Porsche Carrera Cup France 2022

Note Technique 09/2022 v2

SERRAGE RACCORDS D'ETRIER DE FREIN

TIGHTENING BRAKE LINE ADAPTER

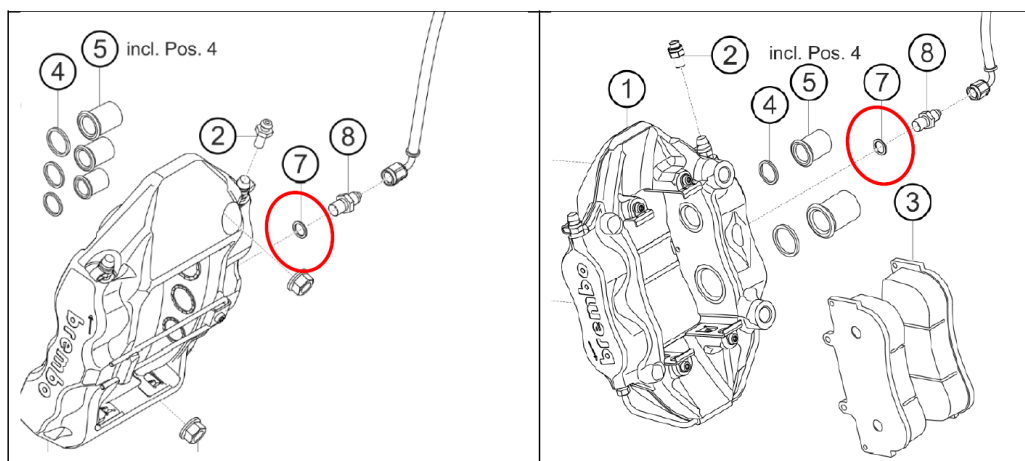
Porsche Motorsport vous informe que, sur toutes les Porsche 991 GT3 Cup (992), le joint d'étanchéité en aluminium entre le raccord adaptateur et l'étrier doit être remplacé par un nouveau joint en cuivre. Ceci s'applique aussi bien aux étriers avant qu'aux aux étriers arrière.

Ancienne référence	Nouvelle référence
N.103.806.3 (aluminium)	900.123.003.20 (cuivre)

Ancien couple de serrage raccord-étrier	Nouveau couple de serrage raccord-étrier
16 N.m	25 N.m

Lorsque vous utilisez de nouveaux joints cuivre, le couple de serrage du raccord sur l'étrier est modifié :

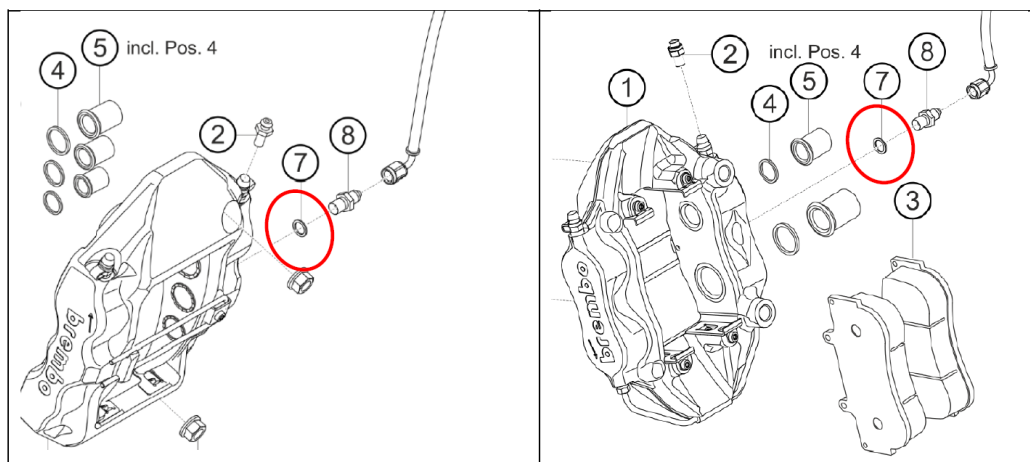
Porsche Motorsport informs that on all Porsche 911 GT3 Cup (992) cars the aluminium seal between the adapter fitting and the brake caliper MUST be replaced by a new copper seal. This applies to both the front and rear brake calipers.

Part number old	Part number new
N.103.806.3 (aluminium)	900.123.003.20 (copper)

Previous tightening torque adapter fitting – brake caliper	New tightening torque adapter fitting – brake caliper
16 N.m	25 N.m

When using the new copper seal, the tightening torque for the new adapter fitting on the brake caliper is adjusted as follows:
